This Service Information bulletin supersedes SI 11 08 11 **dated November 2011.**

The **NEW** attachments are the only changes to this bulletin.

Recall Campaign 11V-521: Replace the Auxiliary Coolant Pump for Turbocharger

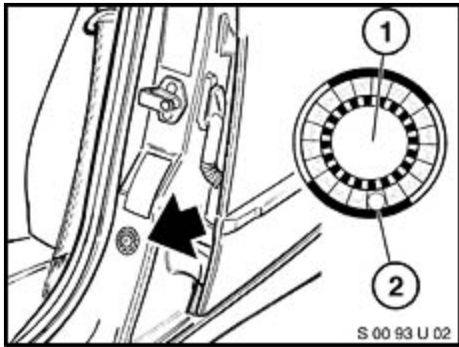
This Recall Campaign has been assigned code number **604**. After the vehicle has been checked and/or corrected, obtain a label (SD 92-403) and:

- A. Emboss your BMW center warranty number in the middle of the label (1);

- B. Punch out code number **604** (2), printed on the label; and
- C. Affix the label to the **B**-pillar as shown.
